Proposal for amendments to GRE-70-15

The text reproduced below was prepared by the expert from OICA to propose editorial amendments to GRE-70-15. The modifications to GRE-70-15 are marked in bold for new or strikethrough for deleted characters.

Annex 20, Page 90 Figure 1, replace figure by:

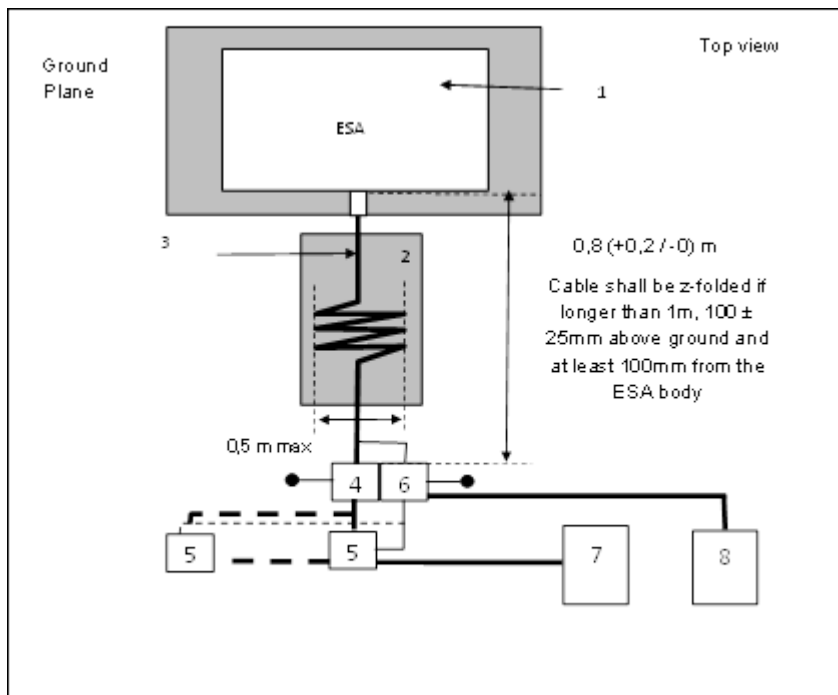
Editorial correction. Since the text contained in a figure of GRE-70-15 is not complete, the above figure shall replace the current one.
